INTERIM MEASURE WORK PLAN SOLID WASTE MANAGEMENT UNIT 42 (SWMU 42)
AREA OF CONCERN 505 (AOC 505) ZONE A WITH TRANSMITTAL CNC CHARLESTON SC
6/28/2001
NAVFAC SOUTHERN

INTERIM MEASURE WORK PLAN

SWMU 42, AOC 505, Zone A

South Carolina Department of Health and Environmental Control comments on: Interim Measures Work Plan for SWMU 42 and AOC 505 located in Zone A of the Charleston Naval Complex, SCO 170 022 560, Revision 0, dated January 2001, received January 26, 2001.

Figure 2 - 2
 Arsenic in Surface and Subsurface Soils
 SWMU 42 / AOC 505
 Charleston Naval Complex

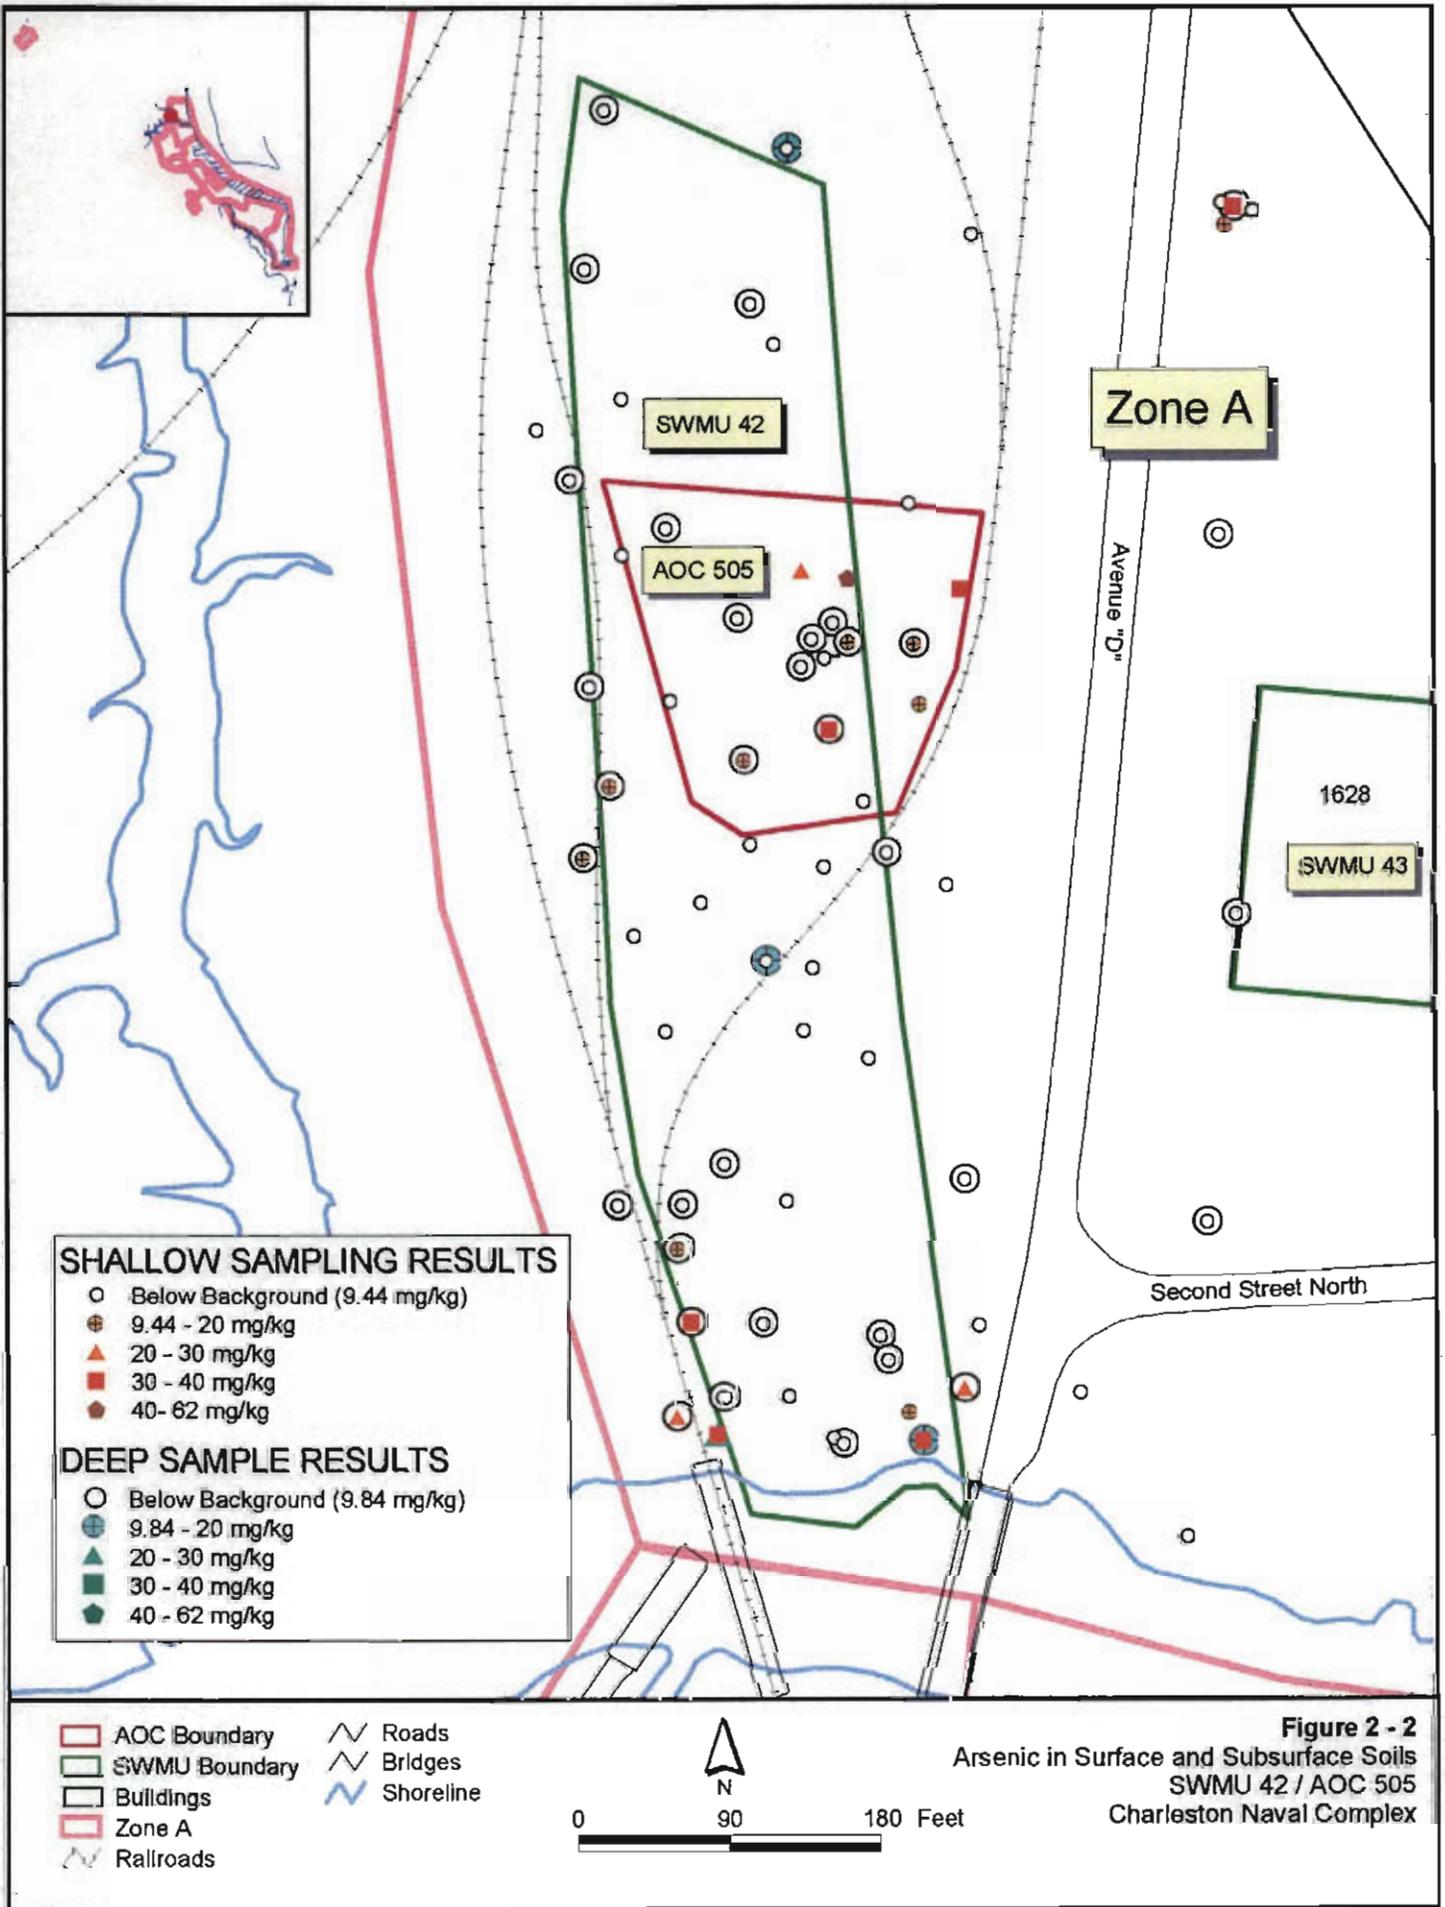
- Specify which locations had hits above the SSL in the text and on the Figure 2-2.**

Response: Subsequent to SCDHEC issuance of these comments, the BCT has agreed upon an approach to define Media Cleanup Standards (MCS) for constituents that are naturally occurring in the site soils at CNC. As presented in BCT meetings (April, May, June 2001)

and correspondence with SCDHEC (April 22, 2001 and June 2, 2001), the MCS is a soil concentration within the background range. When an MCS is based on a concentration within the background range, and that MCS is greater than the SSL, the SSL is not a factor in defining soil cleanup levels. Therefore, identification of which soil samples had hits above the SSL would not add value to the document.
